Project: PRA-ROCR 10(5)
The purpose of this Amendment is to:

Amendment No. 0002
Project PRA-ROCR 10(5)
Rock Creek Park
Solicitation: DTFH71-16-R-00001

Project Name: Beach Drive from Rock Creek Parkway to Maryland State Line

AMENDMENT NO. 2 ◇1	PMIS NO.	NPS NO.	STATE	PROJECT	SHEET NO.
	044965	821 / 100425	DC	PRA-ROCR 10(5)	D23

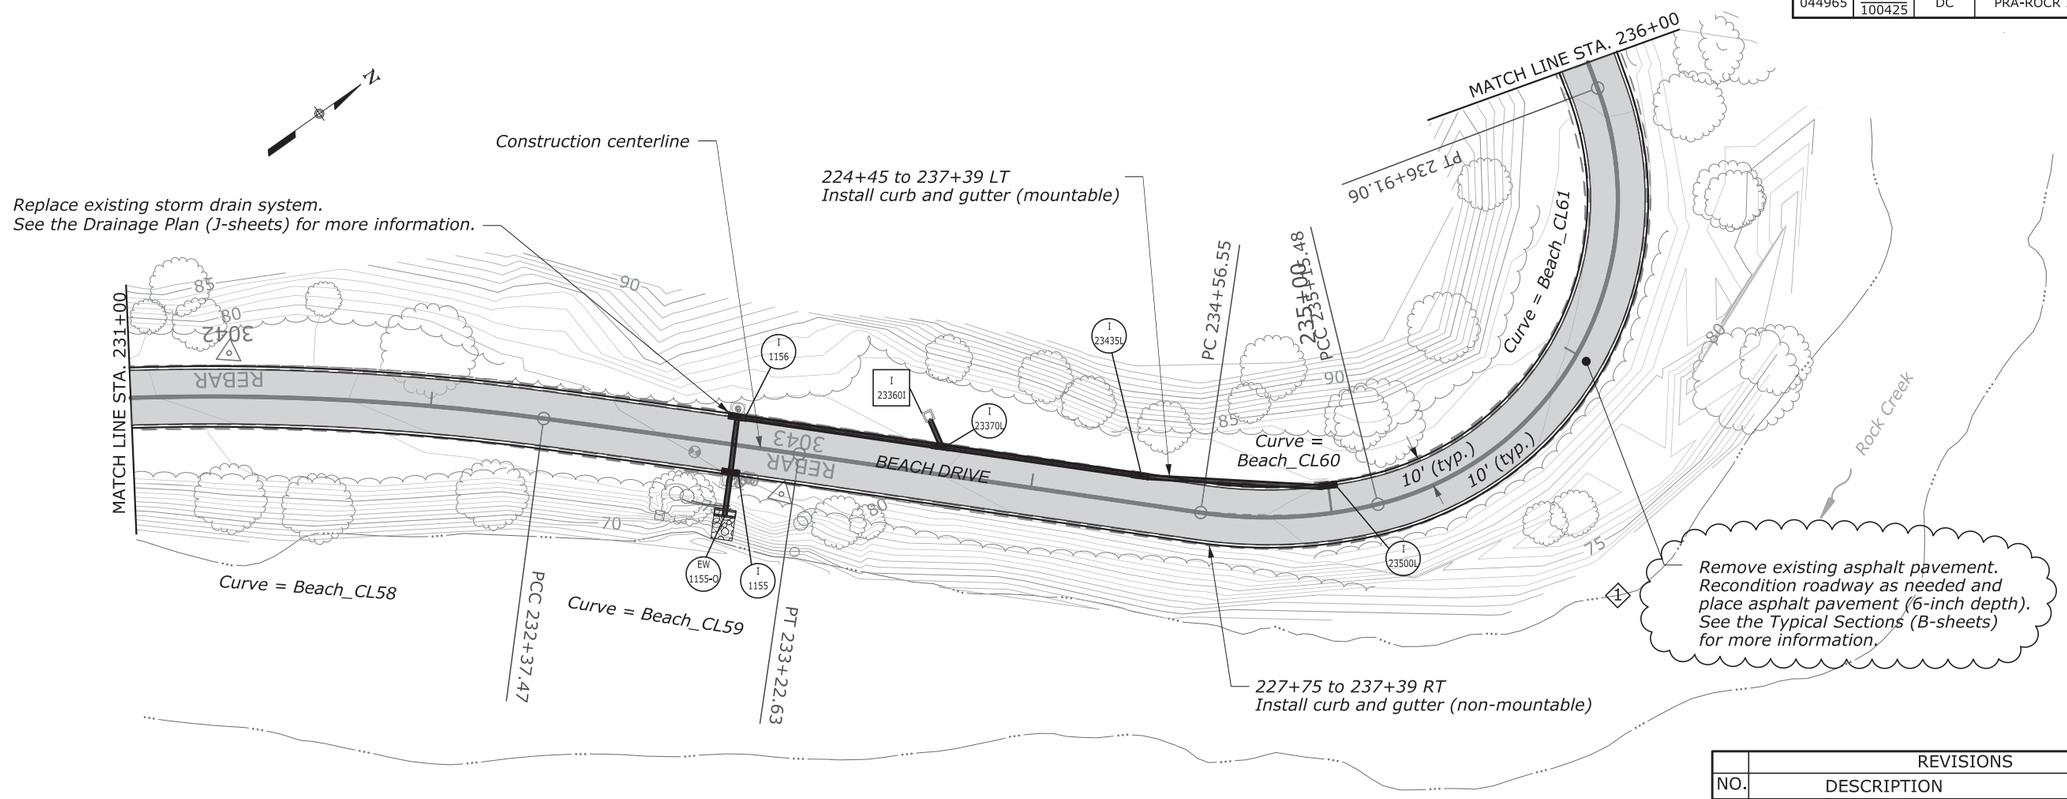
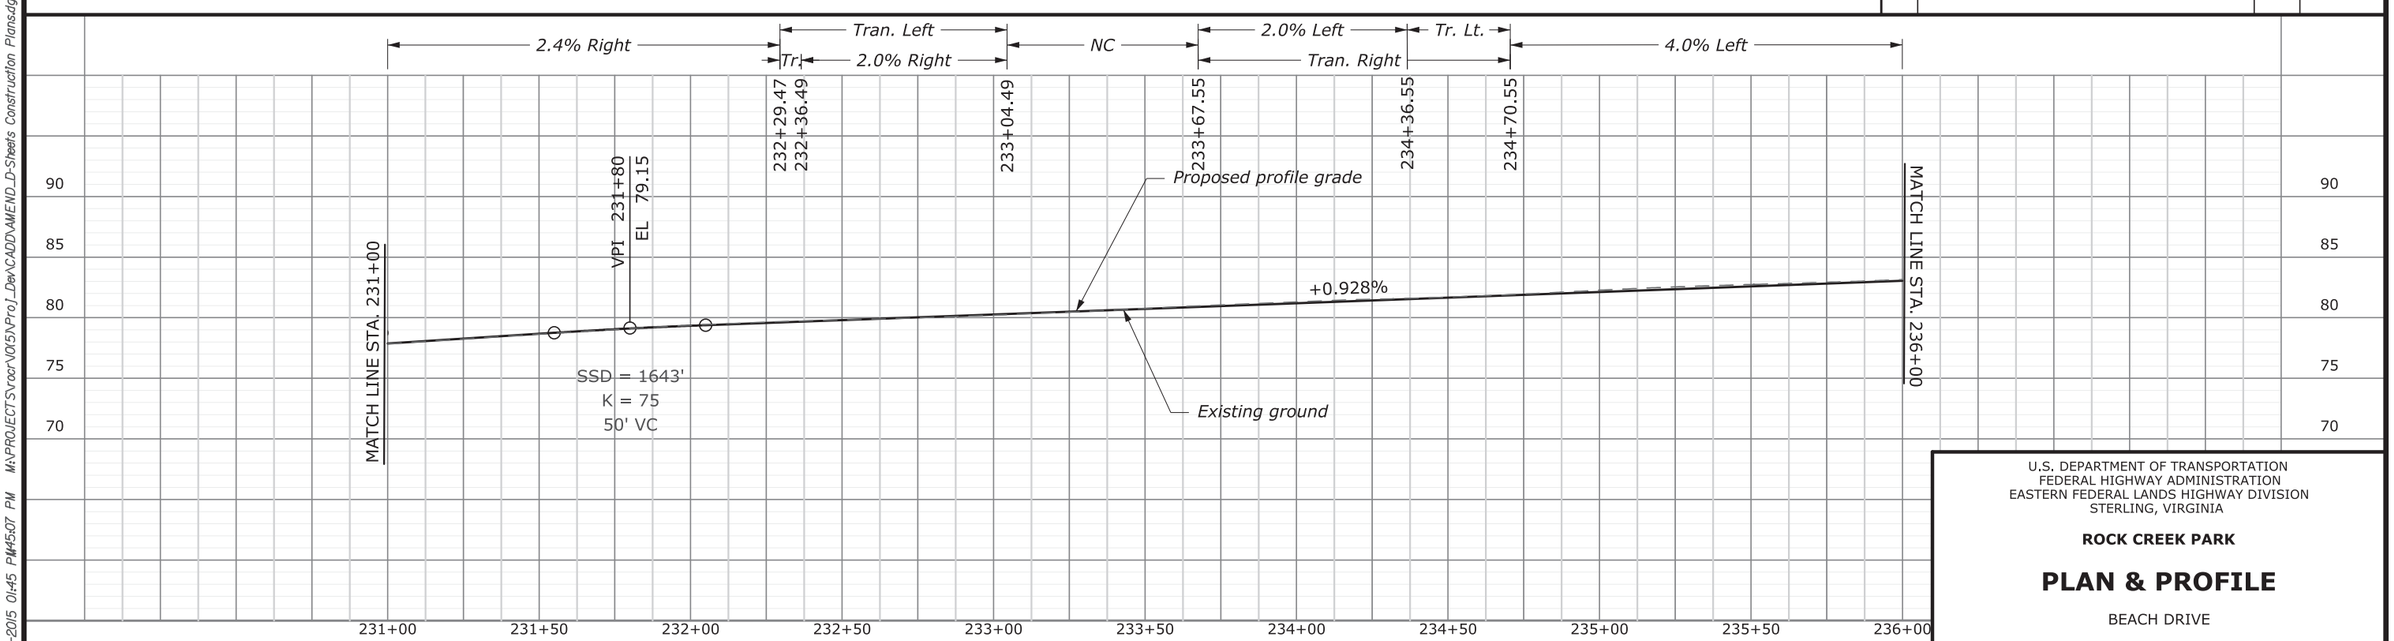
REVISIONS			
NO.	DESCRIPTION	BY	DATE
◇1	Revised the callout to remove the milling requirement.	CC	11/10/15

AMENDMENT NO. 2 ◇1	PMIS NO.	NPS NO.	STATE	PROJECT	SHEET NO.
	044965	821 / 100425	DC	PRA-ROCR 10(5)	D24

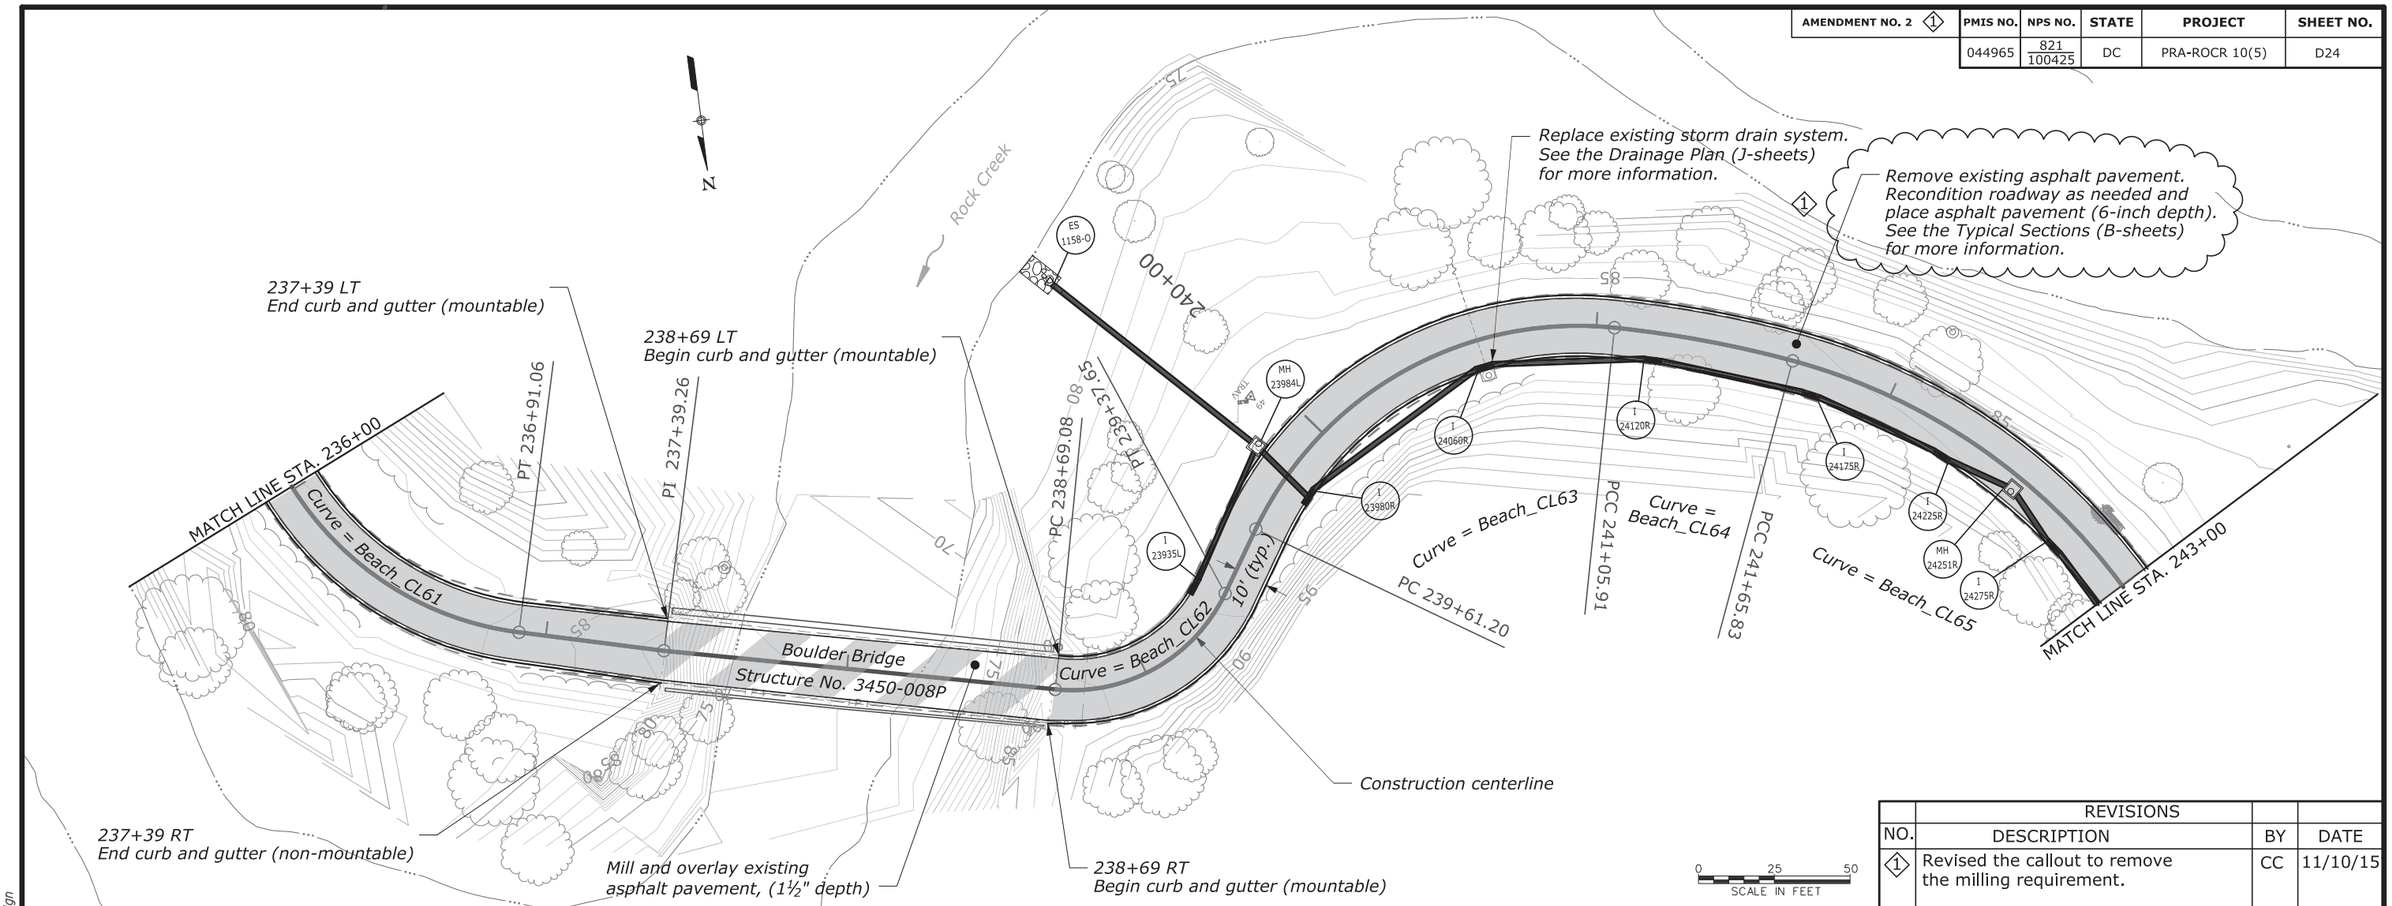
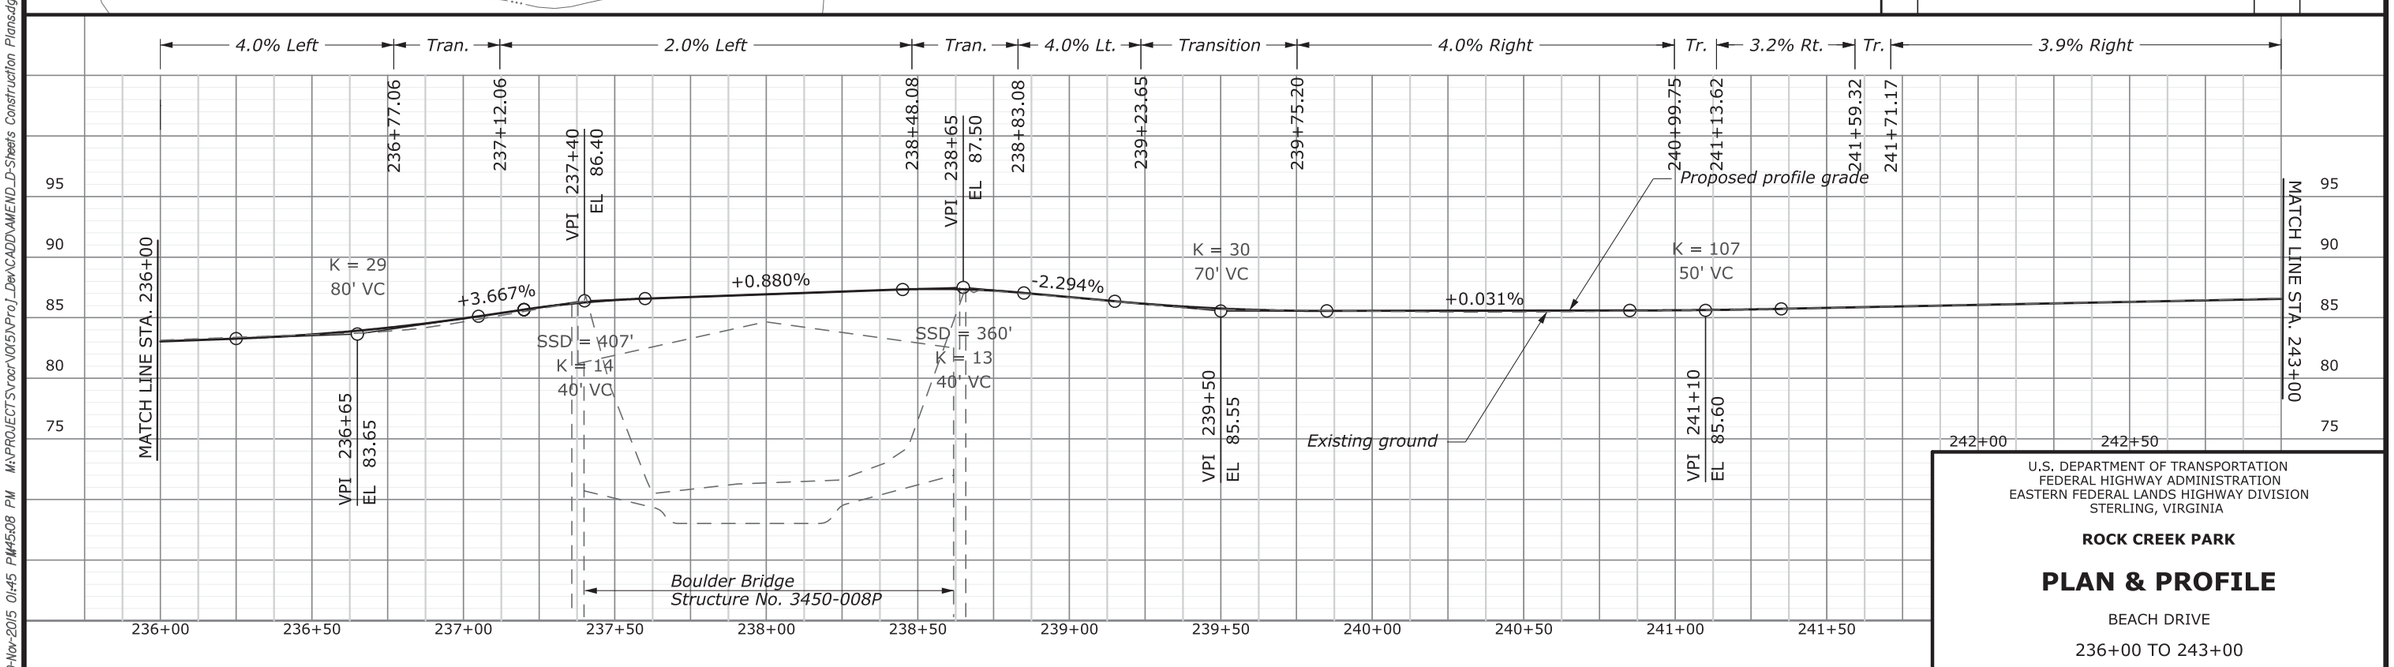
REVISIONS			
NO.	DESCRIPTION	BY	DATE
◇1	Revised the callout to remove the milling requirement.	CC	11/10/15

AMENDMENT NO. 2 ◇1	PMIS NO.	NPS NO.	STATE	PROJECT	SHEET NO.
	044965	821 / 100425	DC	PRA-ROCR 10(5)	D25

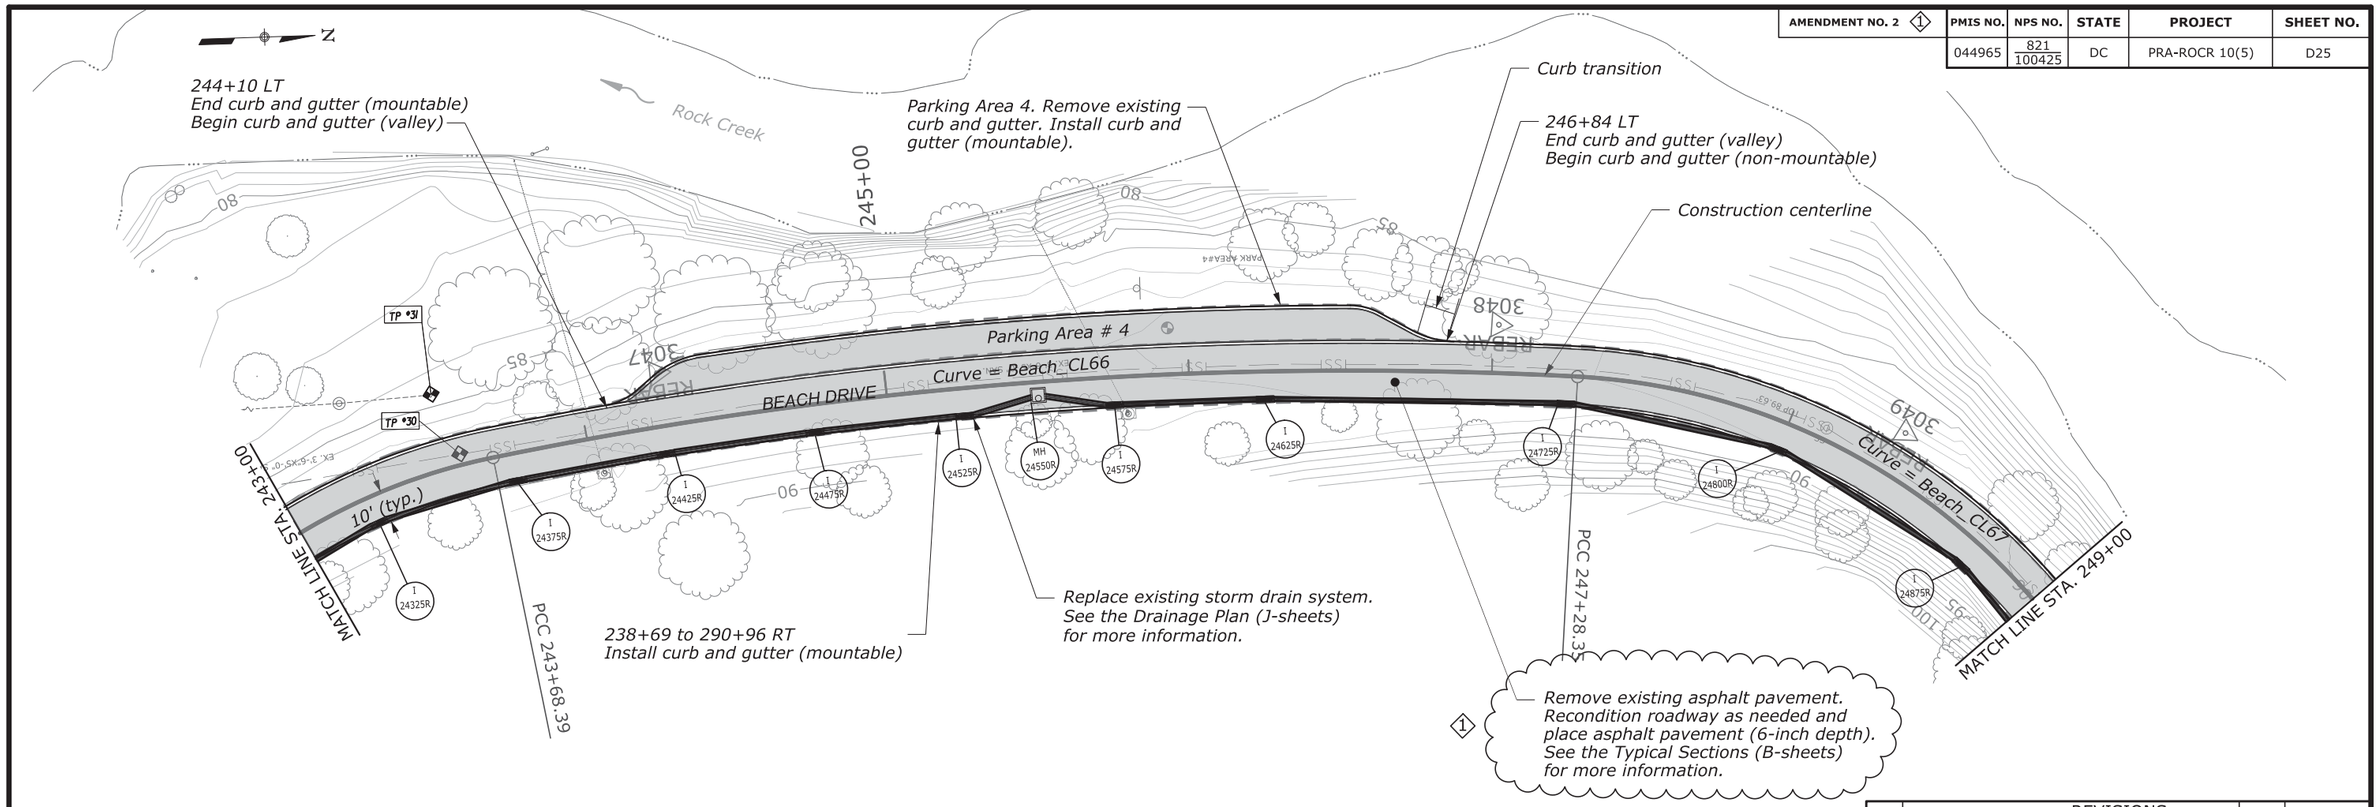
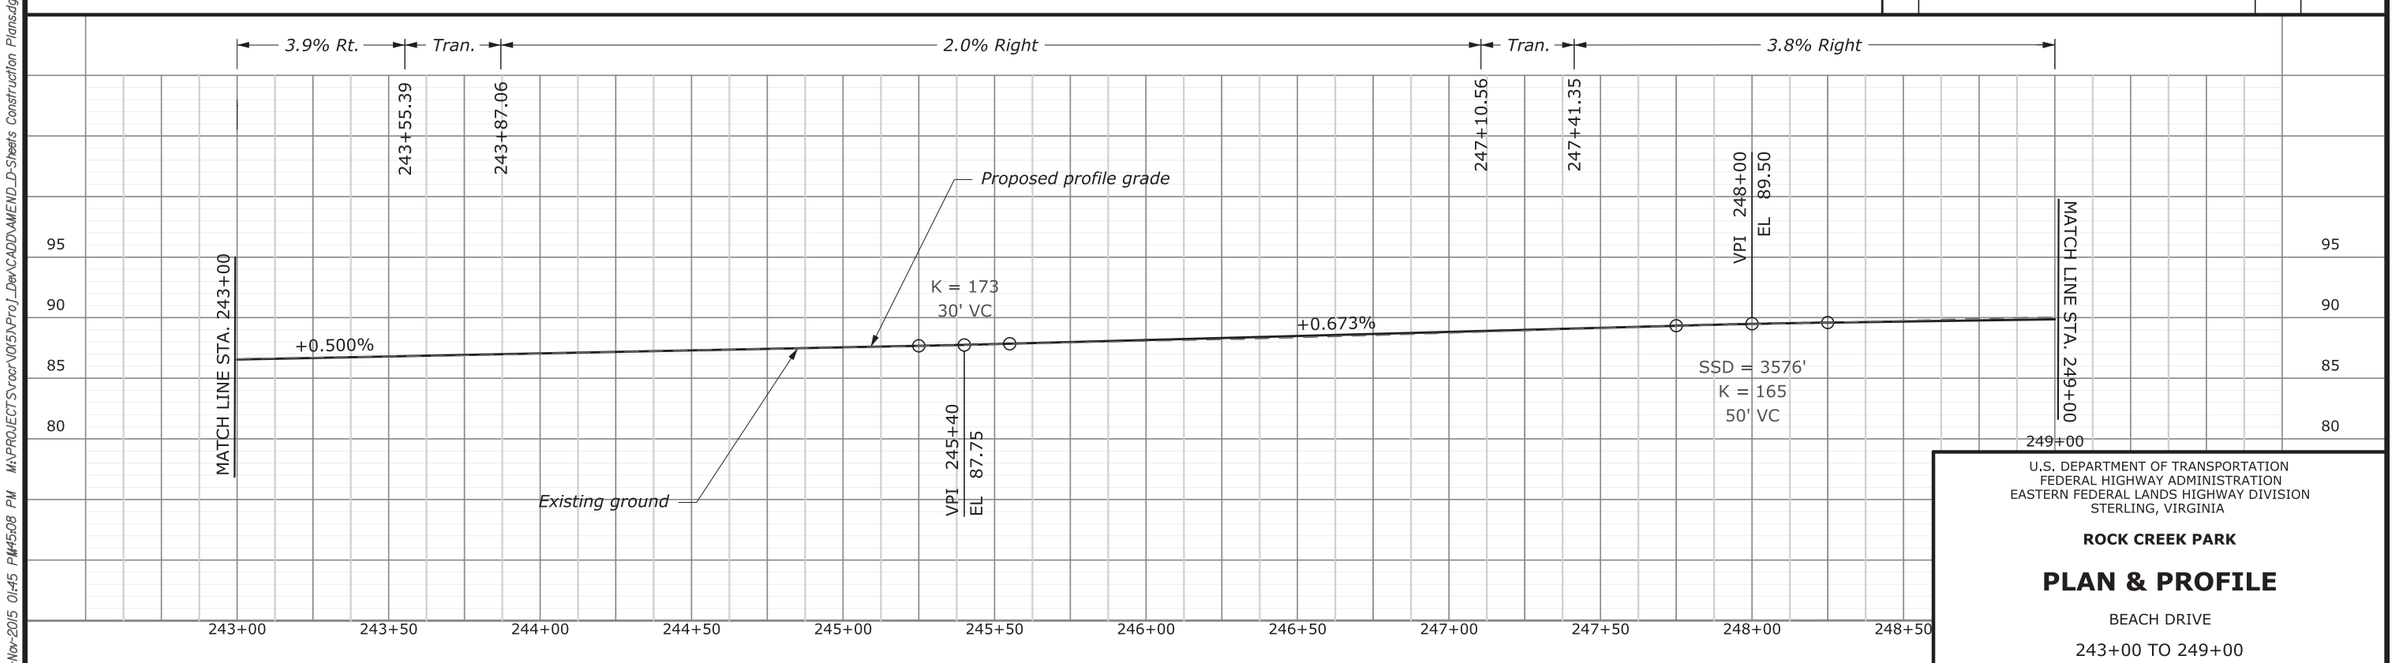
REVISIONS			
NO.	DESCRIPTION	BY	DATE
◇1	Revised the callout to remove the milling requirement.	CC	11/10/15
